November 18, 1999
GO2-99-202

Subject: **WNP-2, OPERATING LICENSE NPF-21
REQUEST FOR AMENDMENT
TECHNICAL SPECIFICATION 4.3.1.2.b
FUEL STORAGE**

Description of Proposed Changes

NEW FUEL STORAGE VAULT FUEL LOADING PATTERN

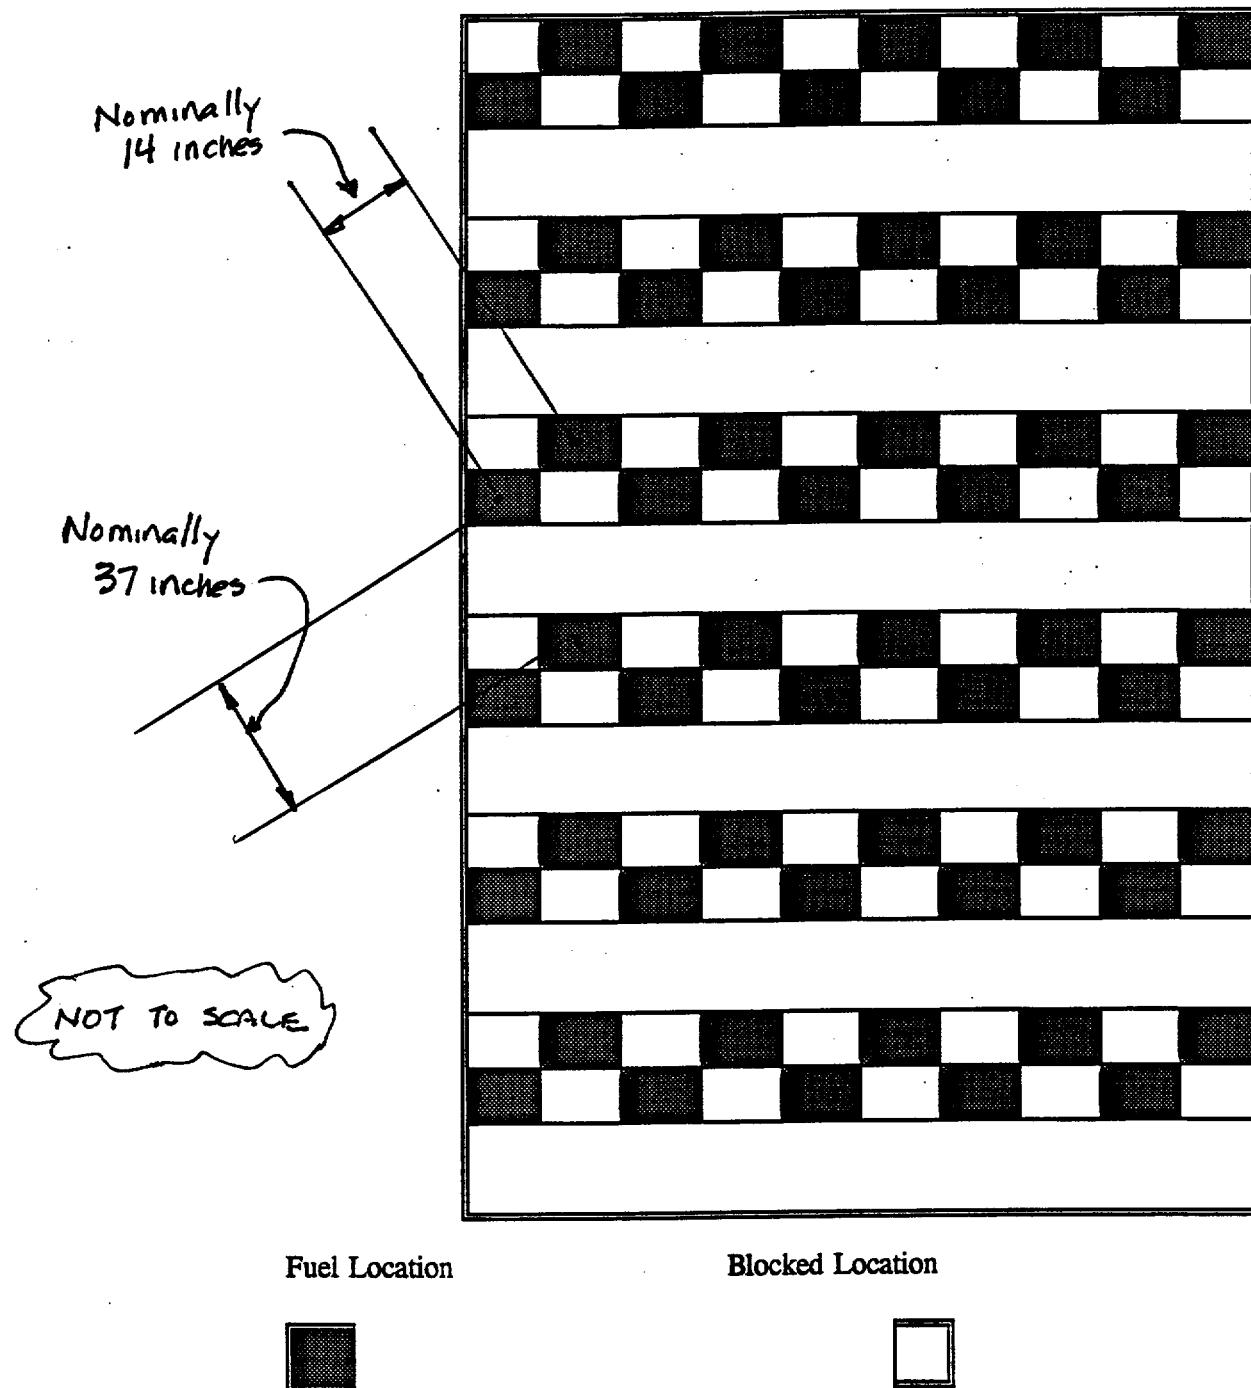
The cell utilization pattern for the fuel consists of 2 contiguous rows in which fuel assemblies may be stored, alternating with 2 contiguous rows in which fuel storage is prohibited. Within a 2-row set in which fuel is stored, alternate cells are physically blocked, in a checkerboard pattern, to prevent inadvertent cell usage. This results in a nominal center-to-center distance between cells for storing fuel assemblies of 14 inches. The nominal center-to-center distance between cells used to store fuel, across the 2-row set in which fuel storage is prohibited, is 37 inches. A sketch of this utilization pattern is included on Page 3 of this attachment.

The above configuration was analyzed to determine the effective neutron multiplication factor, k_{eff} , for (1) geometrical variations resulting from tolerances for the installation, (2) air as the vault atmosphere, and (3) water as the vault atmosphere in a range of densities varying from 1 to 0.02 gm./cc.

- 4.3.1.2 The new fuel storage racks are designed and, with fuel assemblies inserted, shall be maintained with:
- a. (no change)
 - b. A maximum of 60 new fuel assemblies stored in the new fuel storage racks, arranged in 6 spatially separated zones. Within a storage zone, the nominal center-to-center distance between cells for storing fuel assemblies is 14 inches. The nominal center-to-center distance between cells for storing fuel assemblies in adjacent zones is 37 inches. Design features relied upon to spatially limit the placement of fuel bundles within the new fuel vault are required to be installed prior to placement of new fuel bundles in the vault.
